**PALM BEACH COUNTY
PLANNING, ZONING AND BUILDING DEPARTMENT
ZONING DIVISION**

Application No.: ZV/DOA/W-2011-00419
Control No.: 2004-00616
Applicant: KRG Atlantic Delray Beach LLC
Owners: KRG Atlantic Delray Beach LLC
Agent: Urban Design Kilday Studios - Wendy Tuma
Telephone No.: (561) 366-1100
Project Manager: Carol Glasser, Site Planner II

Location: Northwest corner of West Atlantic Avenue and future Lyons Road. (Delray Marketplace)

TITLE: a Type II Zoning Variance REQUEST: to allow alternative street cross sections for Main Street; to eliminate the limitation on Free Standing Structures; to allow an increase in frontage for a single tenant; to allow streets without on-street parking; to allow a reduction in the number of queuing spaces; and, to allow an increase in the height of Building I. **TITLE:** a Development Order Amendment REQUEST: to reconfigure the Site Plan, reduce square footage, modify/delete Conditions of Approval (All Petitions, Architectural Review, Landscape, Signs, Use Limitations), and restart the Commencement of Development clock. **TITLE:** a Waiver REQUEST: to allow a reduction in the length of the Main Street and the minimum length of a block.

Figure 5 Preliminary Site Plan dated April 18, 2011, page 2

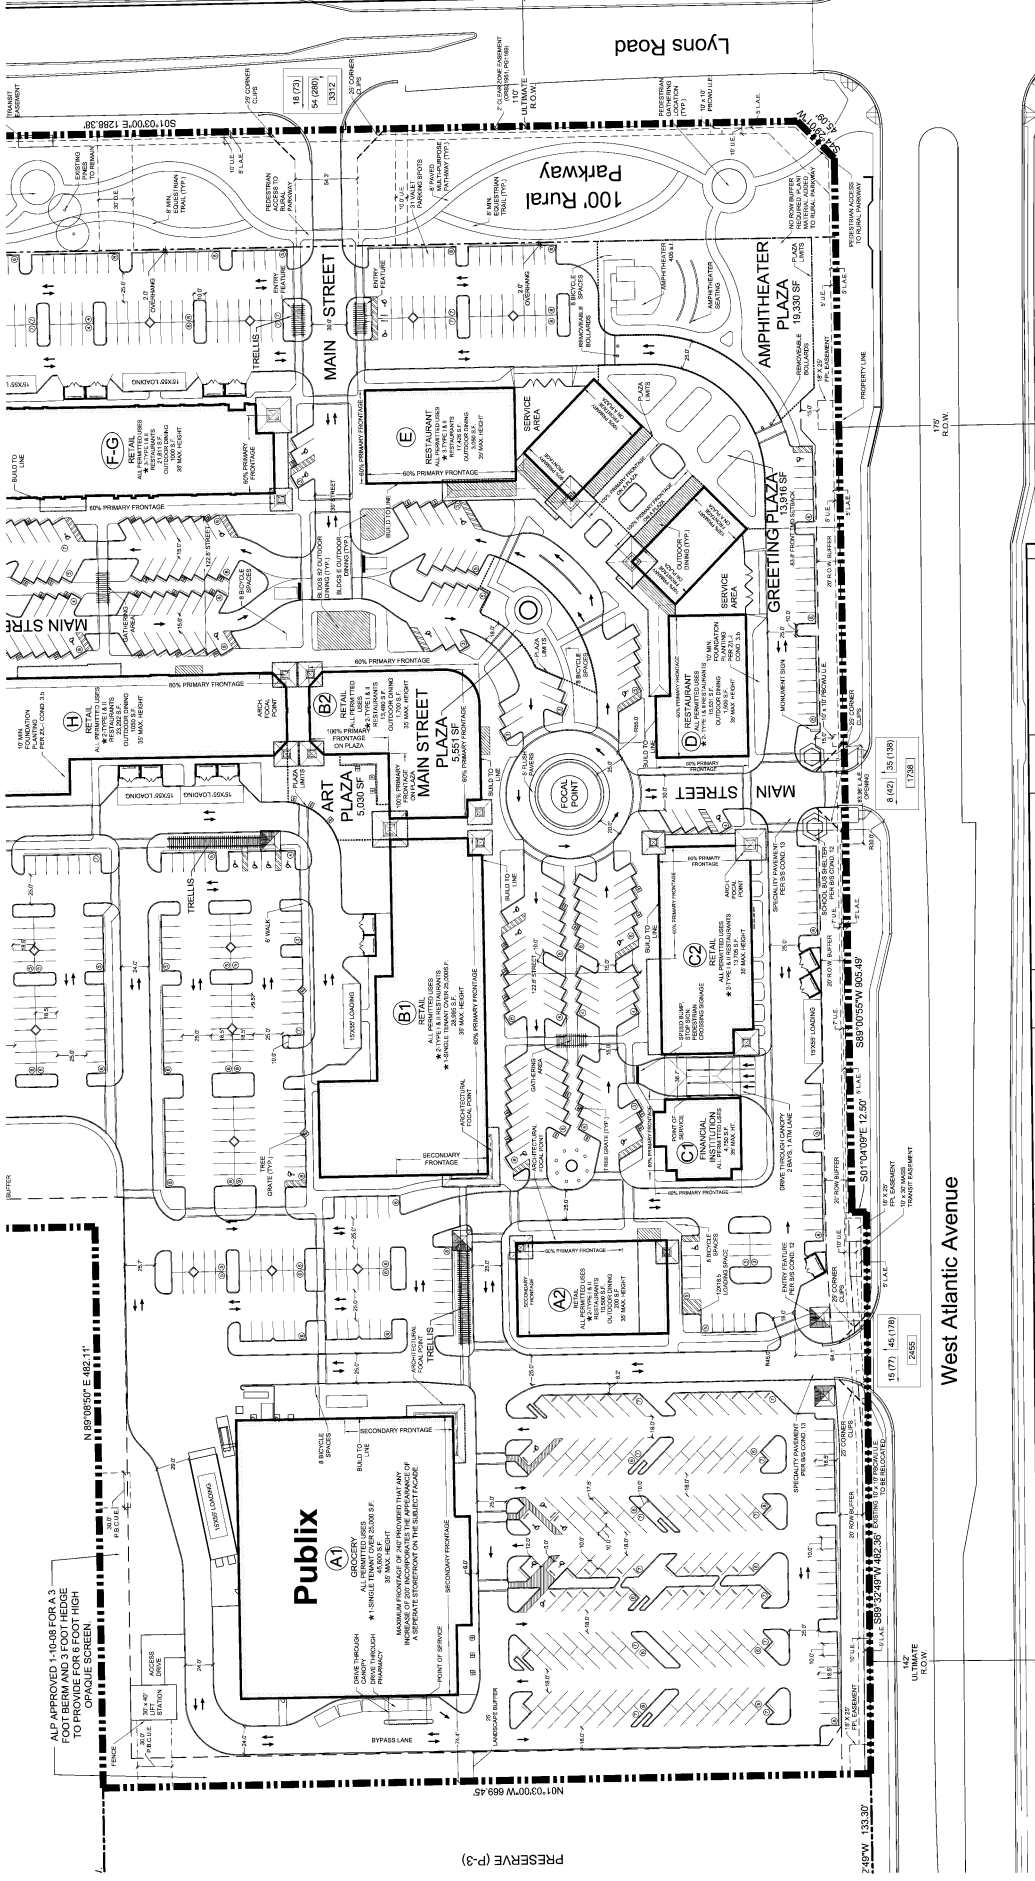
The applicant requests to reconfigure the site plan, reduce square footage (-21,586 square feet to 278,940), restart the Commencement of Development clock pursuant to a new traffic study, and modify/delete Conditions (All Petitions, Architectural Review, Landscape, Signs, Site Design, and Use Limitations). The applicant also requests waivers to reduce the length of Main Street and to reduce the length of a block. The applicant also requests Variances from the limitations on free standing structures; to allow alternative designs for a commercial street in a Traditional Marketplace Development; to increase the frontage for a single tenant (Grocery Store); to reduce the number of queuing spaces for a Financial Institution drive-thrus; relief from the on-street parking requirement; and, to allow an increase of 9 feet in the height of Building I. A total of 1,081 commercial parking spaces will be provided. No changes are proposed to the preserve areas. Access remains from West Atlantic Avenue (2) and future Lyons Road (2).

This variance applies to the following areas on the site plan: Areas south of Buildings 1SW and 1SE; area north of Building E; areas west of Buildings B1, C1 and D; and, Secondary street east of Building A2. The special conditions are created as a result of the shape of the parcel with the 15.04 acre preserve area to the northwest and west creating an L-shaped land area. The only other TMD in the AGR Zoning District is more symmetrically shaped. The special conditions are associated with the areas where streets intersect with the Main Street or where the two Main Streets intersect creating some traffic conflicts. The design of the parking areas were influenced based in part on input from the Palm Beach County Land Development Division to address the potential stacking issue concerns of cars backing out in main circulation areas. All traffic currently entering the site from the south on Lyons Road must enter via the northern entrance (areas south of Buildings 1SW and 1SE) as the southern entrance does not allow for a left turn. Thus, a greater queue distance is provided for incoming traffic to get through the traffic circle without congestion from back-up traffic. A variance is needed particular to this development to allow for the free flow of traffic without the impacts associated with cars backing out into traffic in these areas of the site. The elimination of the few parking spaces at the requested locations, which includes streets at the request of staff that the applicant believes function as drive aisles (west of Buildings B1 and C1), will prevent congestion of cars backing out as vehicles either ingress or egress the development.

1. The approved Preliminary Site Plan is dated April 18, 2011. Modifications to the Development Order inconsistent with the conditions of approval, or changes to the uses or site design beyond the authority of the Development Review Officer (DRO) as established in the Unified Land Development Code (ULDC), must be approved by the Board of County Commissioners or the Zoning Commission. (ONGOING: ZONING - Zoning)

Figure 21 Building A1 (Publix Grocery Store) Conceptual Elevation dated June 20, 2011

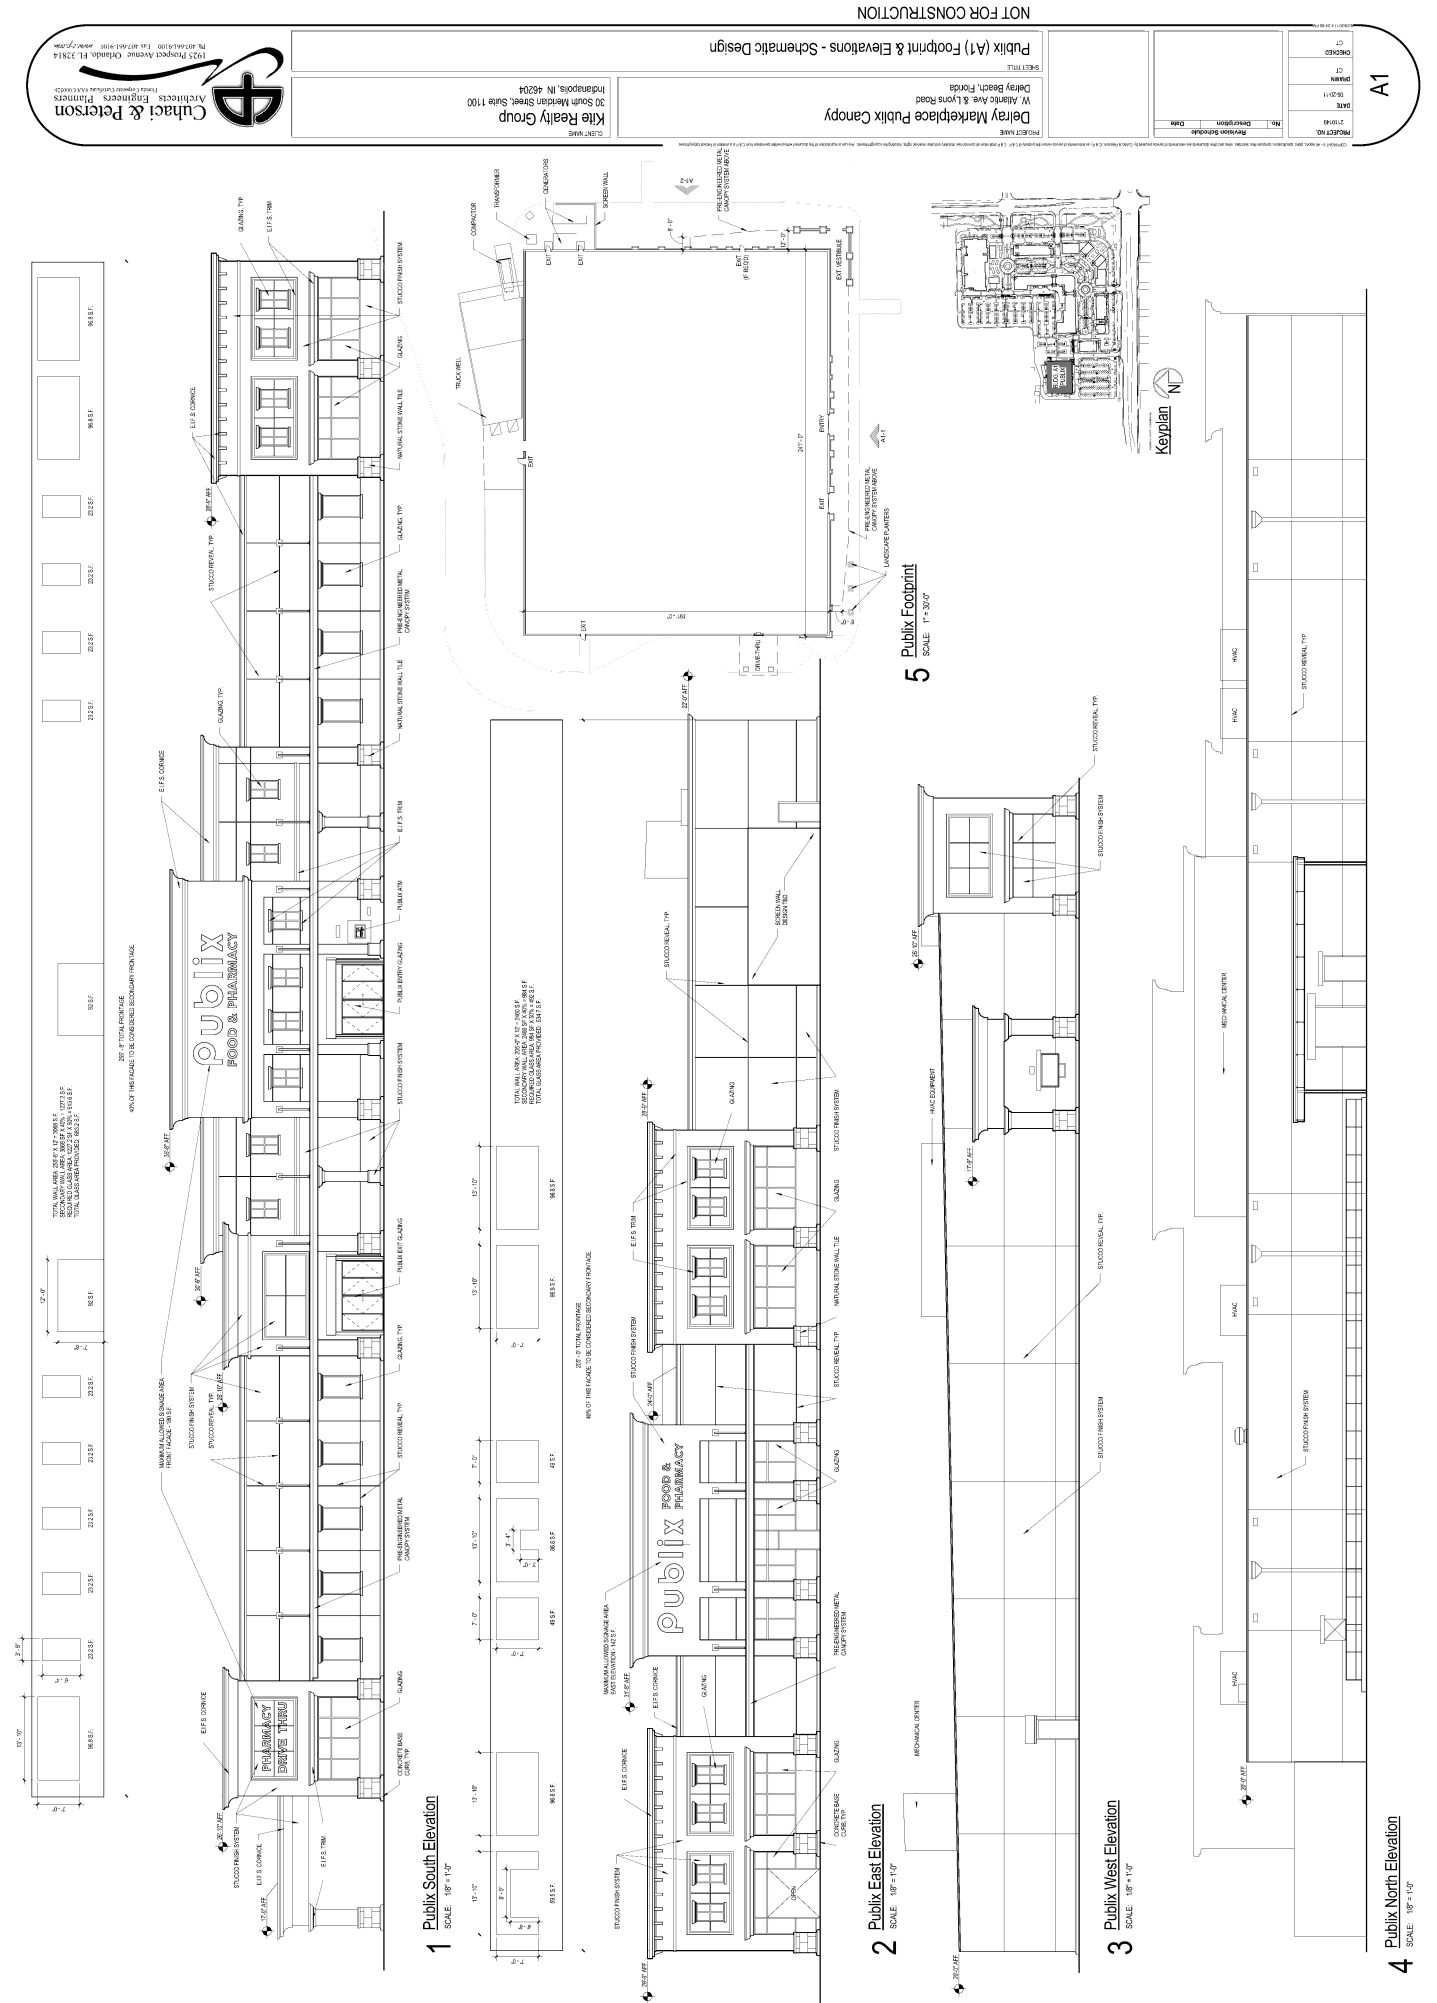
The conceptual elevations dated June 20, 2011 by Cuhaci & Peterson for Building A1; and, the focal point at Building A2 including Main Street conceptual and the Building B1 conceptual elevation dated May 2, 2011 by Wakefield Beasley & Associates are included as Figures 21, 22, and 23. Prior to final approval by the DRO, the Regulating Plan details shall be revised to be consistent with the conceptual architectural theme submitted on June 20, 2011 for preliminary review.

The applicant also requested a variance for Building A1 from Art. 3.F.4.D.1.c.4), which allows for a single tenant of up to 200 feet of building frontage, with an increase to 240 feet in the AGR Tier if the building is designed to provide for the appearance of separate storefronts. Building A1 is designed with a build-to line on the south façade (Primary Entrance) and a second build-to line on the east façade (Secondary or staff entrance). Thus, the Grocery Store has 2 fronts and 2 rears in accordance with the definitions of the build-to-line and lot frontage for a Traditional Development District (TDD). Staff has reviewed conceptual elevations for Building A1 to ensure that the Code requirements will be met prior to final approval by the DRO to allow the south façade to be greater than 200 feet and the pharmacy drive-thru to be located on the west façade.

The proposed development is subject to the Architectural Guidelines (Chapter 5.C.) of the Unified Land Development Code (ULDC). Staff recommends that final architectural elevations for Building A1 and I be submitted for review and approval at submittal for the final DRO Site Plan approval. As the project is located within AGR TMD, specific additional design guidelines apply to both the buildings and site layout. While some conceptual elevations have been submitted, the final architectural elevations shall be designed to be consistent with the Final Site Plan, all applicable Conditions of Approval, and ULDC requirements.
